STORMWATER MANAGEMENT REPORT
PROPOSED RESIDENTIAL SUBDIVISION
2050 DUNROBIN ROAD
CITY OF OTTAWA

PROJECT #: 200977

Issued in support of the Subdivision Agreement
Issued in response to Review Comments

APPENDIX K: RESPONSES TO REVIEW COMMENTS

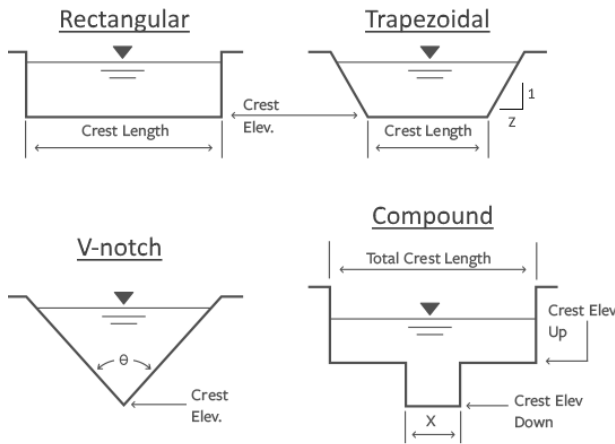
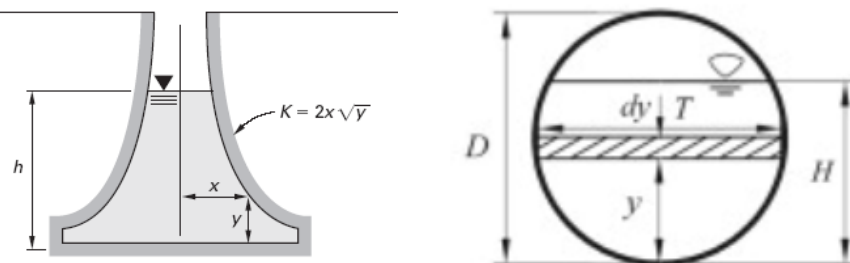
13. Section 7.1.3 provides an equation that defines the discharge rate through the orifices. Please show that the equation, found on page 33 (pdf sheet 38) fulfills the criteria of use. It is not clear how this formula applies in this case.

Reference to the equation has been provided.

A weir can be of virtually any shape.

It is acknowledged that the equation used is not completely accurate having a maximum error of up to 2.4 percent between the value derived using the provided equation and the values obtained when using separate equations to calculate orifice flow and weir flow. The peak discharge during the 100 year storm event is in the order of 70 L/s. A 2.4 percent error would indicate this number could vary from 68.6 to 71.4 L/s. This error is not significant when considering that the post-development runoff during a 100 year storm event is more than 15 L/s less than the pre-development runoff rate.
